## Proposed Revisions to a Standard Plans Index

(Please provide all information	n — Incomplete form	s will be returned)
<u>Contact</u>	Information:	Standard Plan	<u>s:</u>
Date: May 26, 2020		Index Number:	102-604
Originator: Derwood Sheppard		Sheet Number (s)	: 1
Phone: (850) 414-4334		Index Title: Two-	Lane, Two-Way, Work in intersection
Email: de	rwood.sheppard@dot.state.fl.us		
<u>Summar</u>	y of the changes:		
and Cor Sheet 2	: Added Details from 102-605 as New Sheet 1; nditions; Renamed Index; Moved Original Shee : Revised and Consolidated Details; Revised Non Signs' Table (Moved to 102-600).	t 1 Details to Sheet 2	
<u>Commer</u>	ntary / Background:		
Yes N		e of person contacted	
	tion Package Includes: hand deliver package to Rick Jenkins)  Redline Mark-ups Proposed Standard Plan Instruction (SPI) Revised SPI Other Support Documents		Implementation:  ☐ Design Bulletin (Interim) ☐ DCE Memo ☐ Program Mgmt. Bulletin ☐ FY-Standard Plans (Next Release)

= LANE CLOSURE FOR WORK MORE THAN 200' FROM INTERSECTION =

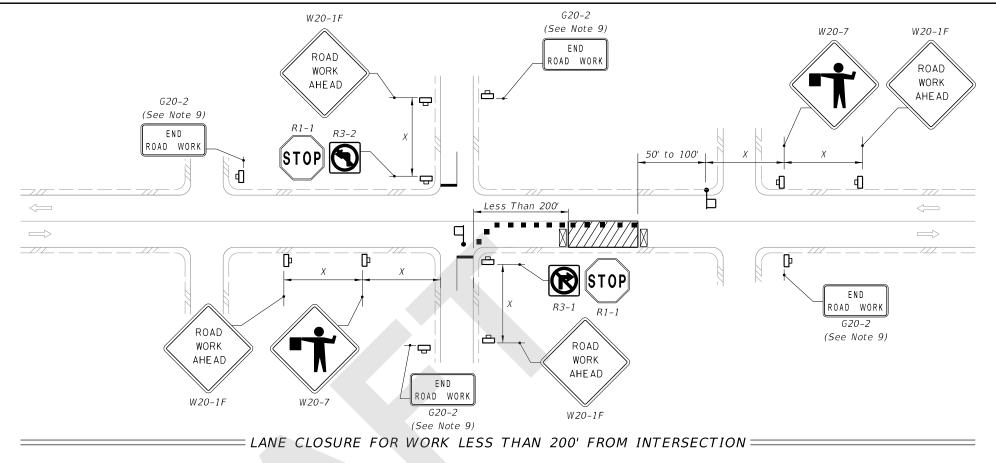
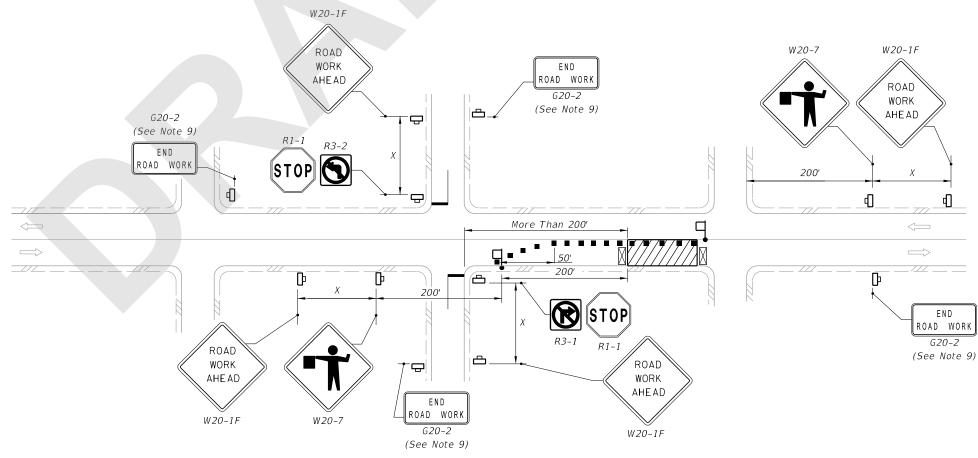
ADDED DETAILS FROM 102-605 AS NEW SHEET 1
